# Errata for 2021 Uniform Plumbing Code Illustrated Training Manual – 1st Printing

The following are changes that we found after the first printing of the *2021 Uniform Plumbing Code Illustrated Training Manual*. These changes may apply to your code book. Thank you.

**FIGURE 310.1**  
**PROHIBITED OR RESTRICTED FITTINGS**

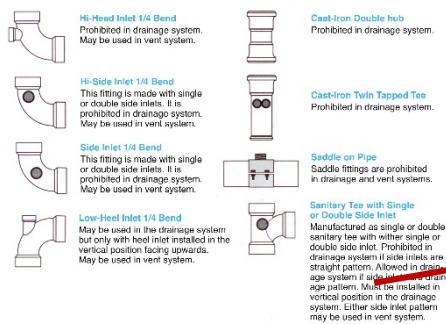
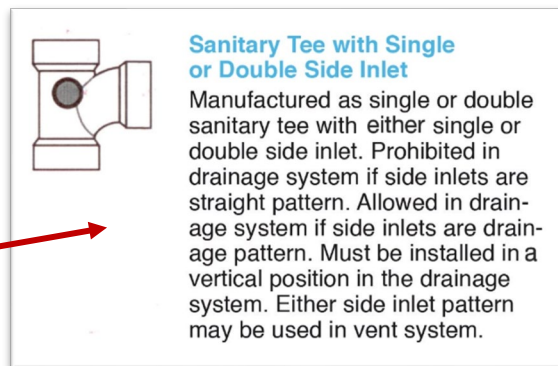
**Figure 310.1 Prohibited or Restricted Fittings** – The commentary in the figure for "Sanitary Tee with Single or Double Side Inlet" should be corrected as follows:

Manufactured as single or double sanitary tee with ~~w~~**either** single or double inlet. Prohibited in drainage system if side inlets are straight pattern. Allowed in drainage system if side inlets are drainage pattern. Must be installed in a vertical position in the drainage system. Either side inlet patterns may be used in vent system.
